## APPEAL SUMMARY

<b>Appeal ID:</b> 31981	<b>Project Address:</b> 4626 SE Clinton St.
<b>Hearing Date:</b> 11/15/23	<b>Appellant Name:</b> Isaac Adams
<b>Case No.:</b> B-012	<b>Appellant Phone:</b> 503-226-1575
<b>Appeal Type:</b> Building	<b>Plans Examiner/Inspector:</b> Chanel Horn
<b>Project Type:</b> Commercial	<b>Stories:</b> 4 <b>Occupancy:</b> R-2 <b>Construction Type:</b> V-A
<b>Building/Business Name:</b> Peaceful Villa	<b>Fire Sprinklers:</b> Yes - NFPA-13 throughout
<b>Appeal Involves:</b> Reconsideration of appeal	<b>LUR or Permit Application No.:</b> 23-035590-CO
<b>Plan Submitted Option:</b> pdf <a href="#">[File 1]</a> <a href="#">[File 2]</a>	<b>Proposed use:</b> Residential Apartments

The purpose of this appeal is to allow the public restroom serving an outdoor amenity lounge in an apartment building to be located two stories below the space.

CODE ANALYSIS PLAN -  
SOUTH BLDG - LEVEL 03

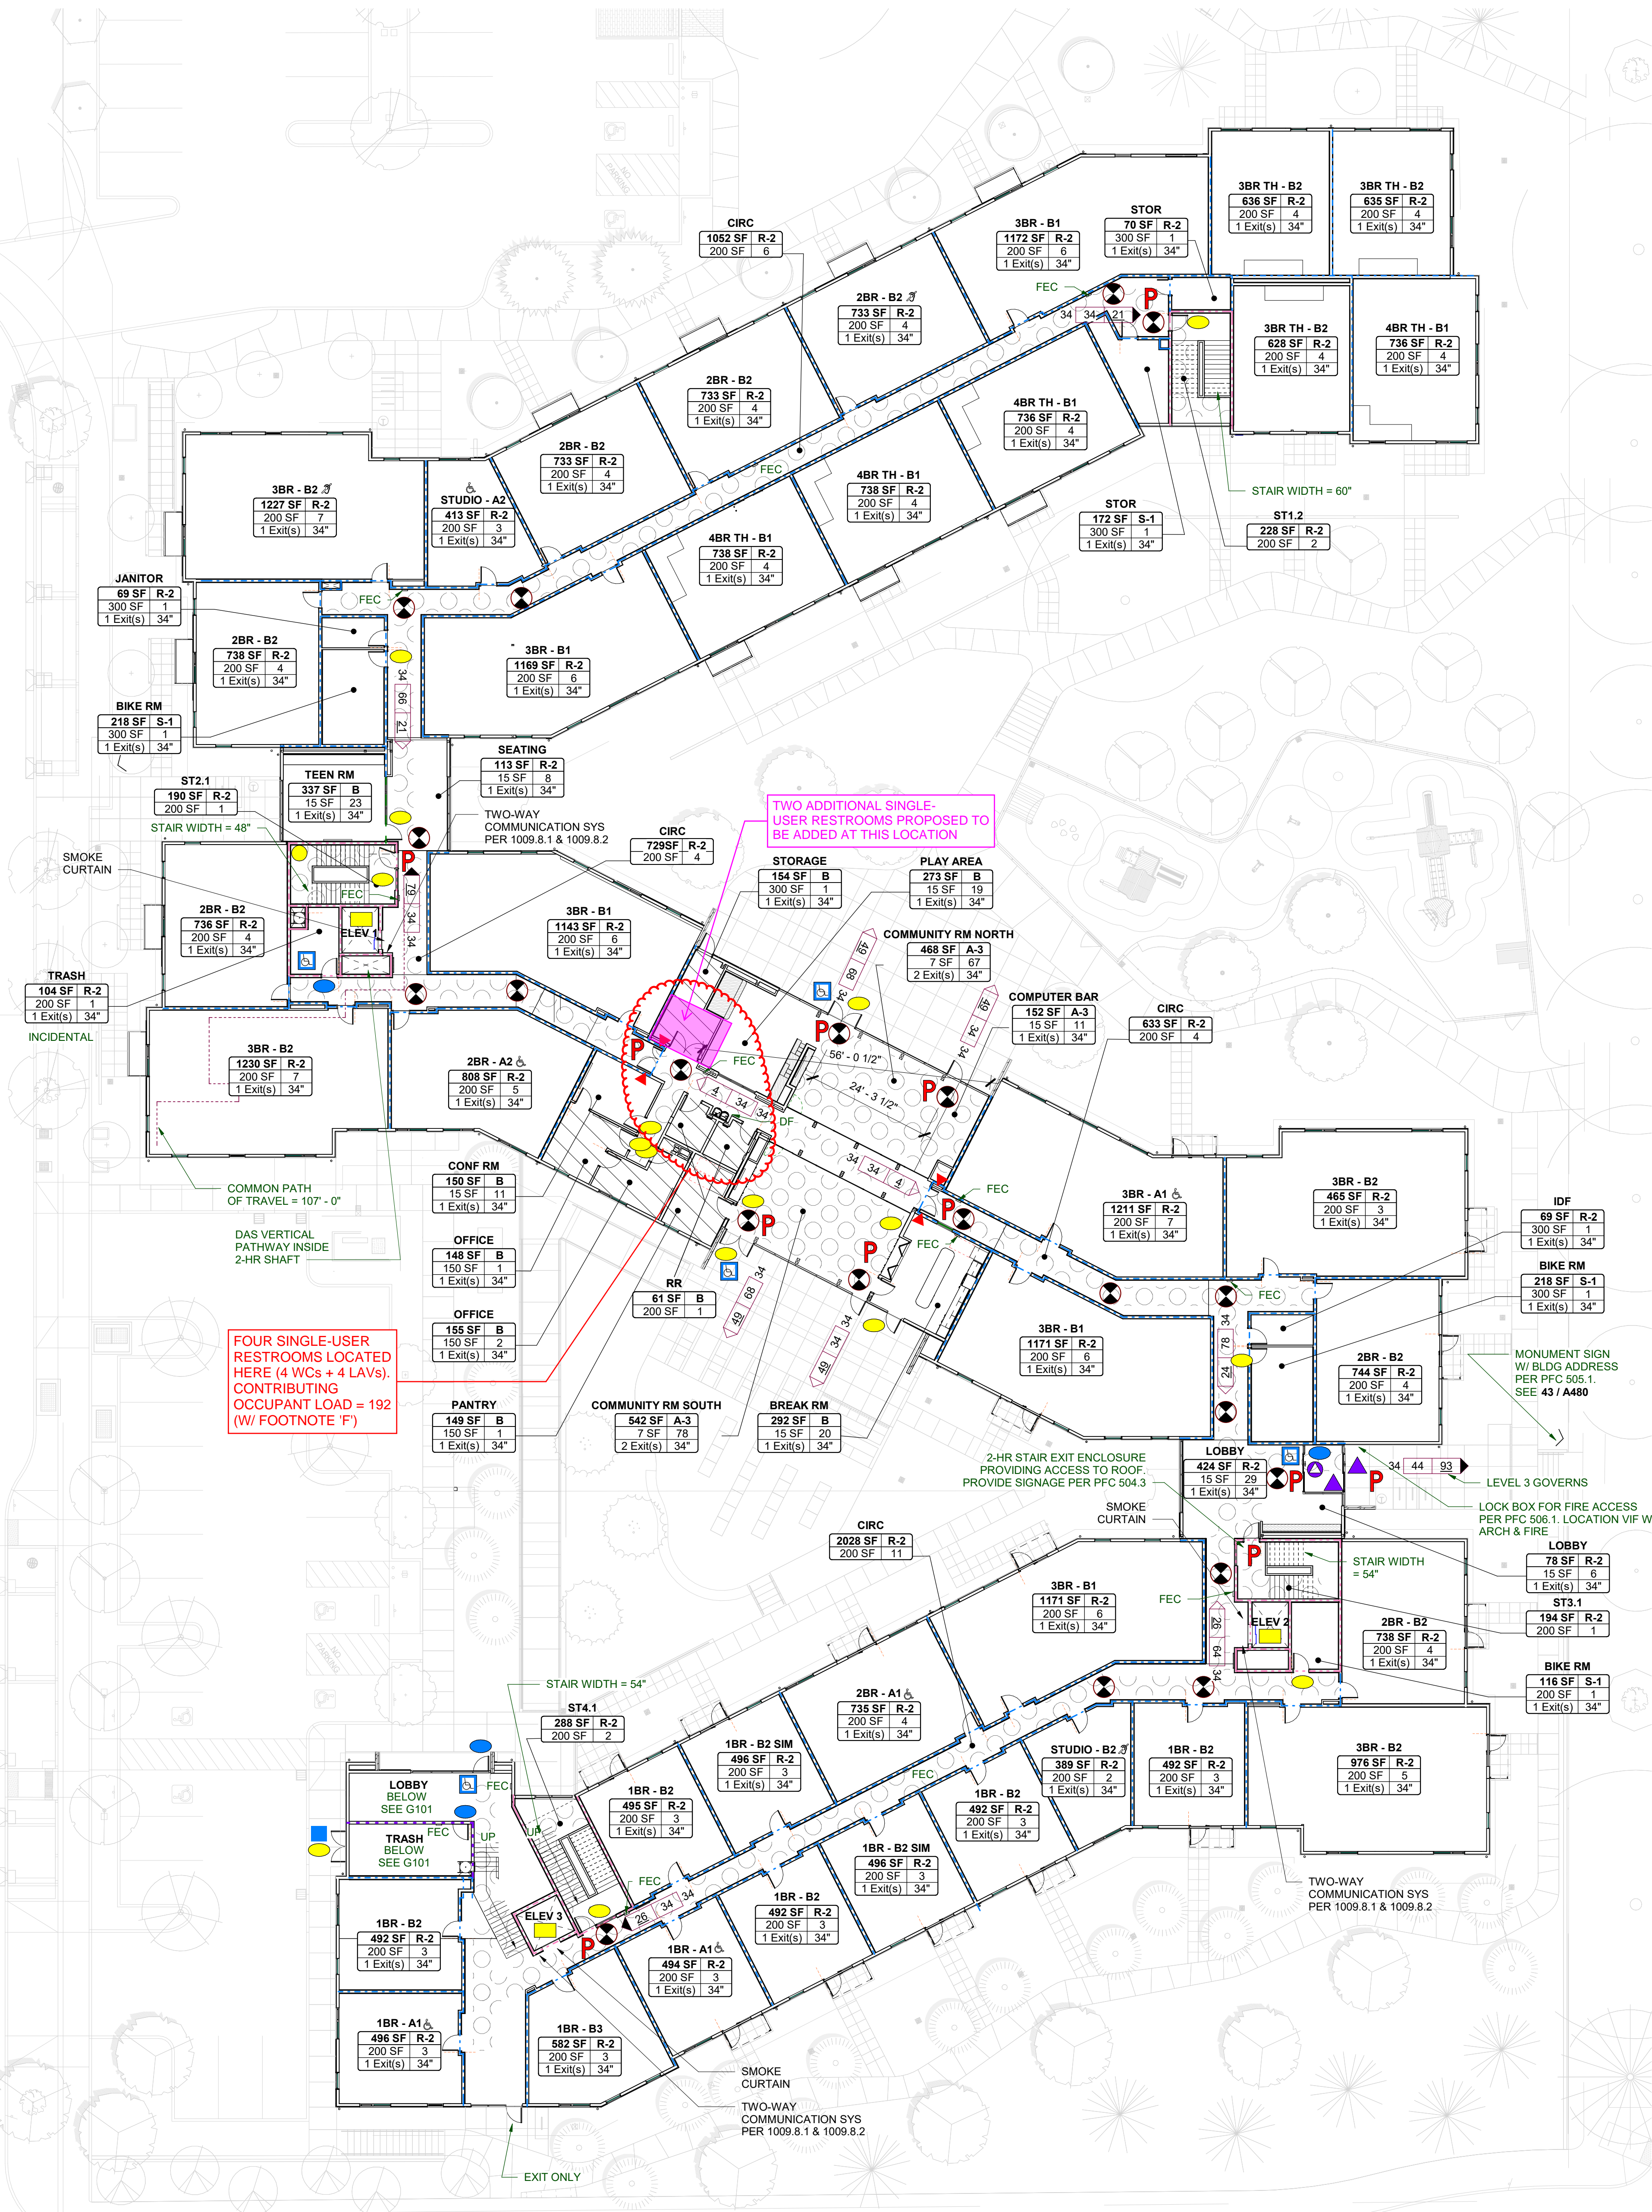
However, for three amenity spaces on the upper floors (Indoor Lounge #290, Outdoor Lounge #281 and Outdoor Lounge #390) we request an alternate from the building official that would allow us to exclude them from the fixture counts given their proximity to plumbing fixtures in adjacent dwelling units and their limited use by residents and residents' invited guests only. We also ask that we may exclude the distance and number of stories traveled from Bike Room #391 to the public restrooms on Level 2 given that that bike room is a transitory stop for residents coming/going from their dwelling unit.

LOUNGE 281 -  
PROPOSED TO BE  
EXCLUDED FROM  
PLUMBING  
FIXTURE CALCS

223FT TRAVEL DISTANCE FROM  
FURTHEST UNIT TO LOUNGE

226FT TRAVEL DISTANCE FROM  
FURTHEST UNIT TO LOUNGE

LOUNGE 290 -  
PROPOSED TO BE  
EXCLUDED FROM  
PLUMBING FIXTURE  
CALCS

Copyright 30158  
PERMIT SETCODE ANALYSIS PLAN -  
SOUTH BLDG - LEVEL 04

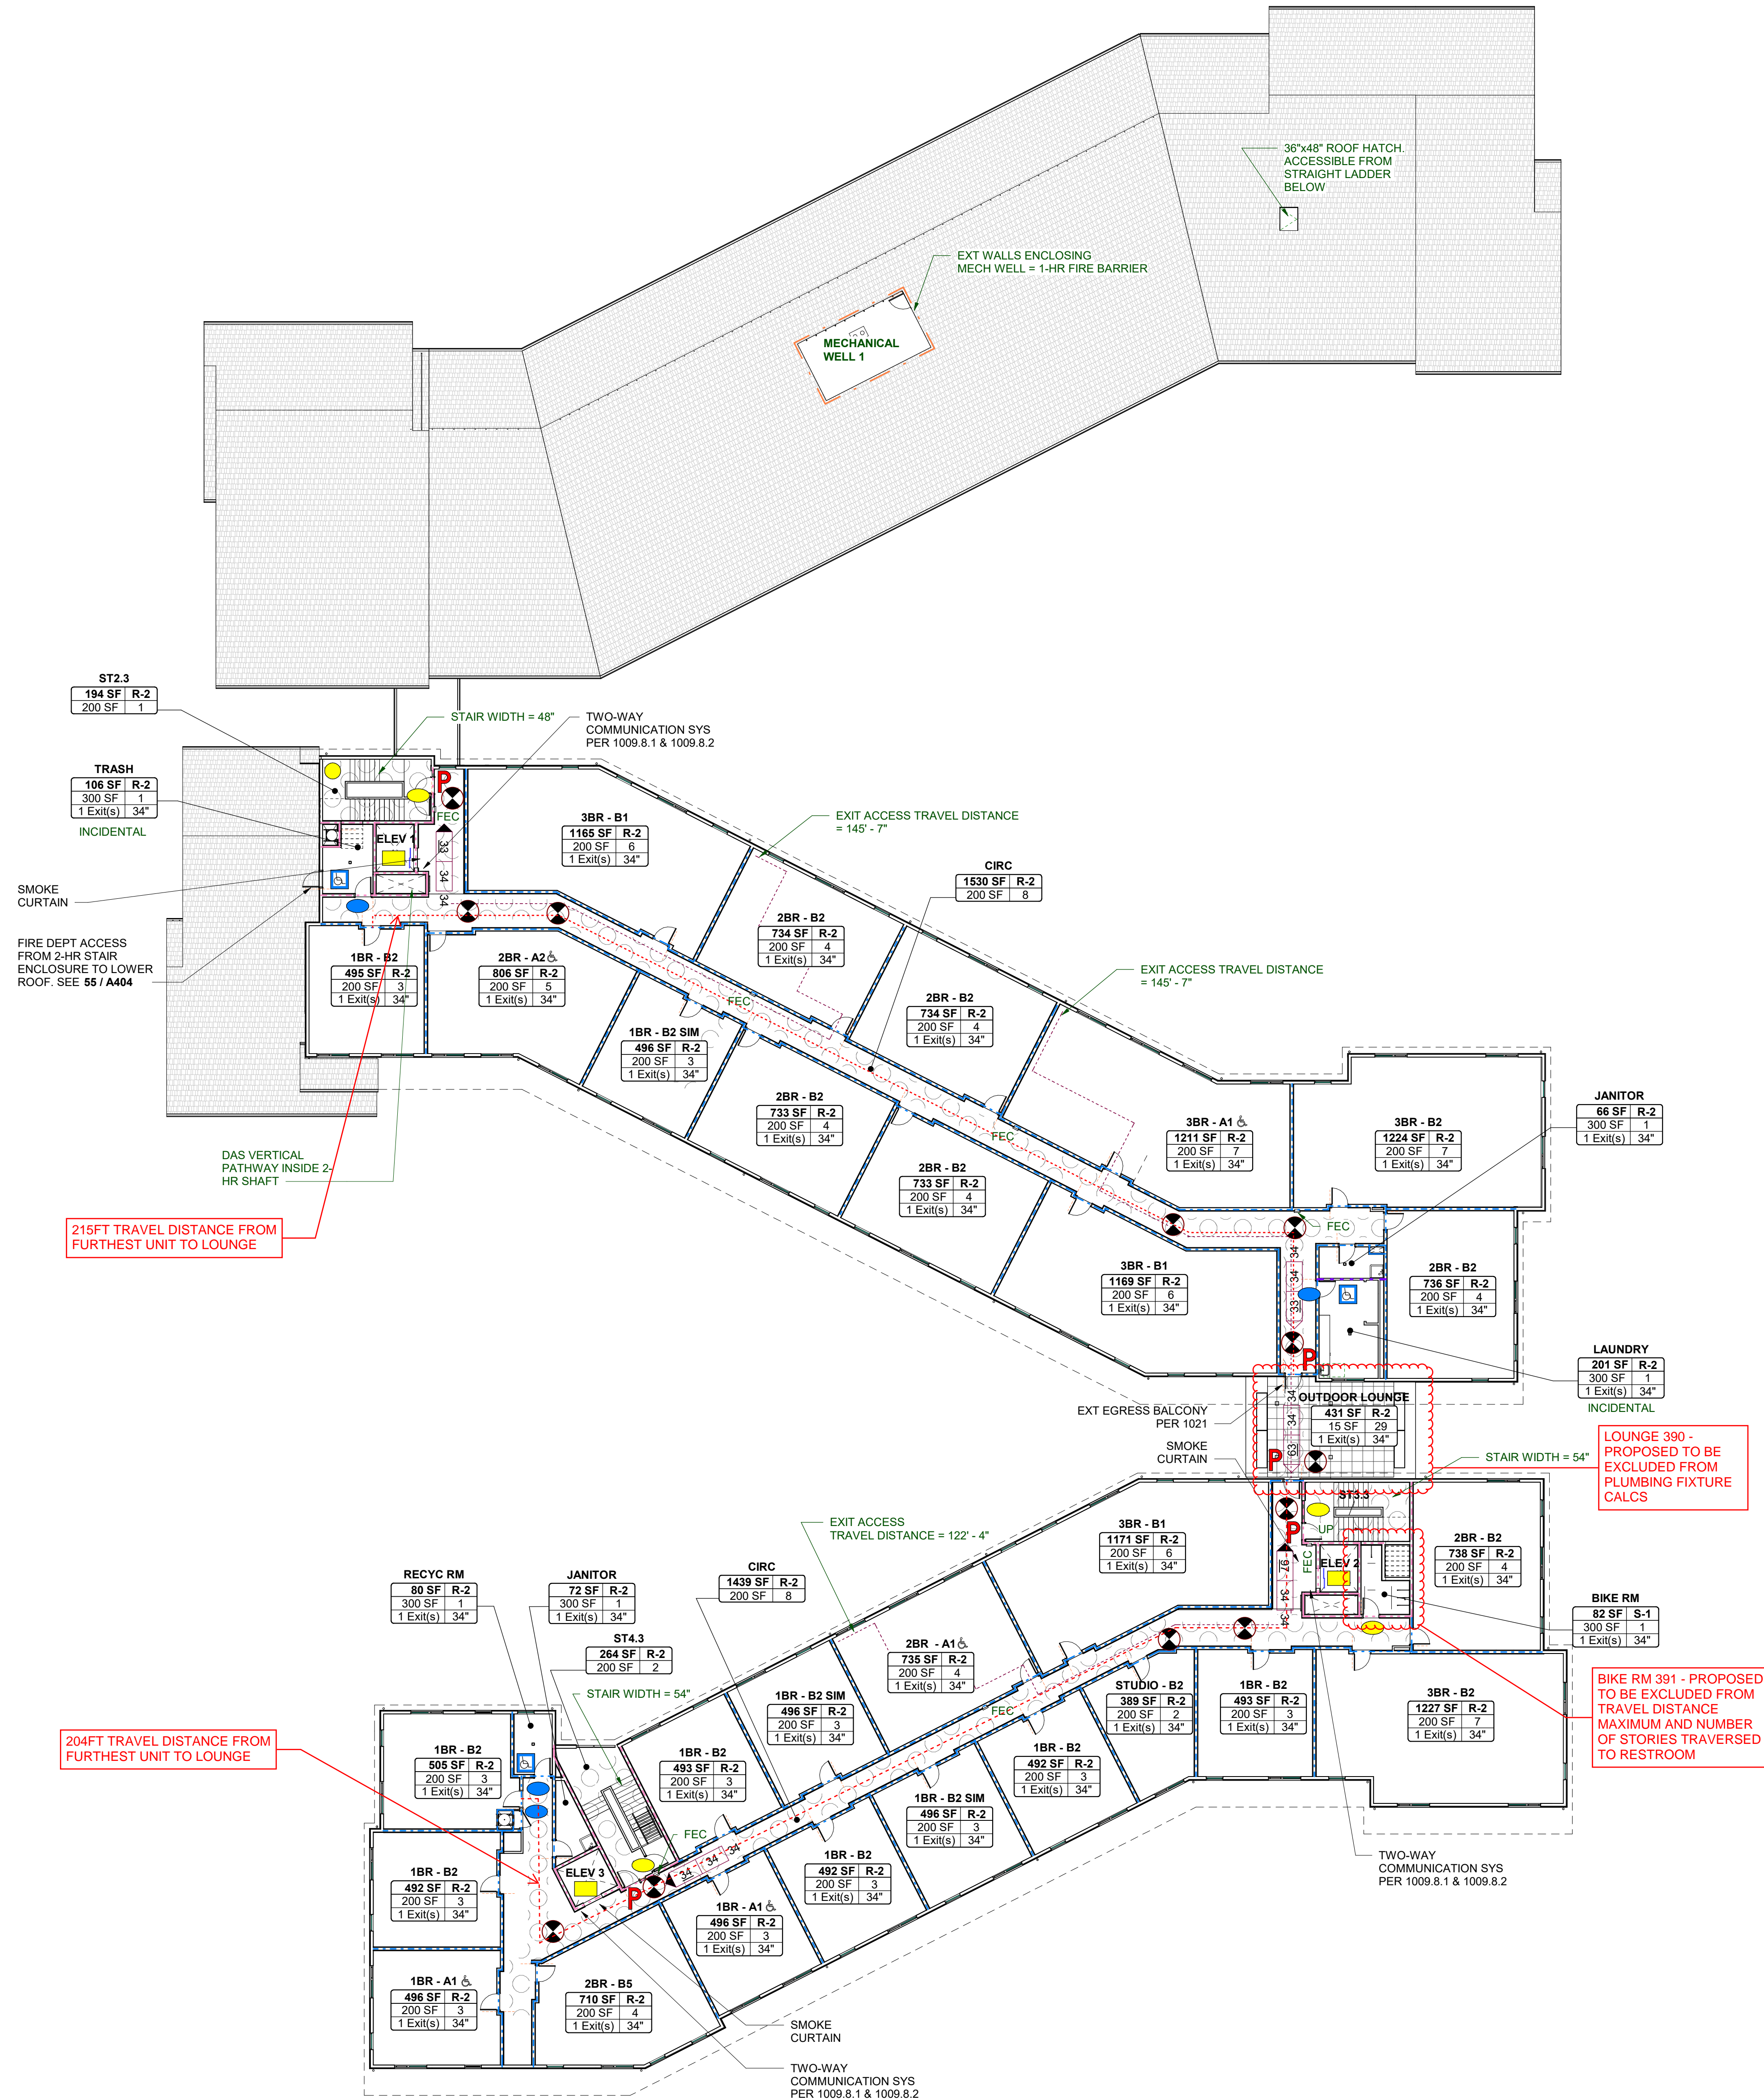
The users of the Outdoor Lounge (Room #390) on Level 4 will be adequately served by the public restrooms on Level 2 – and by the bathrooms in the adjacent dwelling units - for the following reasons:

- The actual use of the lounge is intended to be casual, daily use, primarily by residents, with occasional, invited guests. Access control (card readers) will prevent visitors and the public from accessing the lounge without the accompaniment of a resident.
- The lounge is not intended for significant or formal gatherings, or for use by outside groups, and its size does not support those types of gatherings.
- The travel distance from the lounge to the nearest public restroom (Restroom 183C) is 258ft, well below the 500ft maximum.
- All residential units on the fourth floor are within 226 feet of the lounge area; this means that the travel distance from the lounge area back to the unit plumbing fixtures is approximately the same or less, plus the distance within the unit. This is less than the 500 ft distance that would be allowed to access a public restroom.

For the amenity lounge space on the fourth floor (Outdoor Lounge #390) we request an alternate from the building official that would allow users to travel two stories to the nearest public toilet facility given the lounge's proximity to plumbing fixtures in adjacent dwelling units and its limited use by residents and residents' invited guests only.

Given that all nearby dwelling units include at least one bathroom, and that the travel distance from the lounge to the toilet facilities on Level 2 is significantly less than 500ft, we believe the proposed design has met the intent of the code-prescribed proximity of fixtures.

**Location of toilet facilities two stories below the space where required to be provided: Granted as proposed.**
